Product Change Notification

Date Issued :	April 24, 2024	PCN Number :	514891
Reason for Change :	Change to Product		
Description of Change :	This notification is to inform you about changes that are being made to the part(s) as identified in the list. This change will affect the appearance of the parts.		
Reason for Short Notice :	Update Previously Issued Change Notice		
Assessment of Change :	First Article Inspection Reliability Test Report/s		
Planned Implementation Date :	May 31, 2024		
Customer Sample Availability Date:	May 03, 2024		
Last date to request Samples by Customer : April 30, 2024			
Please note if Samples are not requested as per Customer Samples Request date, it may take additional 4-6 weeks to arrange Samples.			
Traceability Code Markings / Date :	Date code

2156740051 Revision A

Before Picture

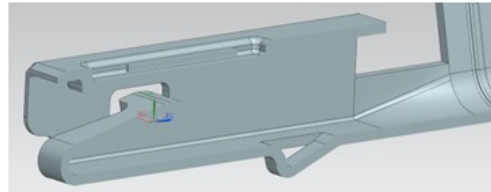
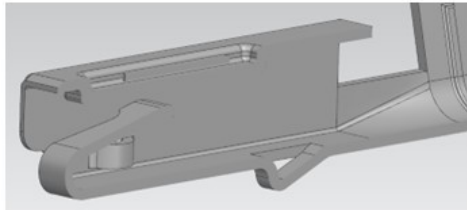
- Changing cantilever stop from a detent to a window and updating die to increase capacity
 - This is an update to previously issued PCN 514277, communicated Jan, 23, 2024
- Product Impact
 - The new window design enhances fit, preventing the cantilever from being overstressed.
- Part Number Impact
 - See attached impacted parts list
- PPAP not provided for industrial product
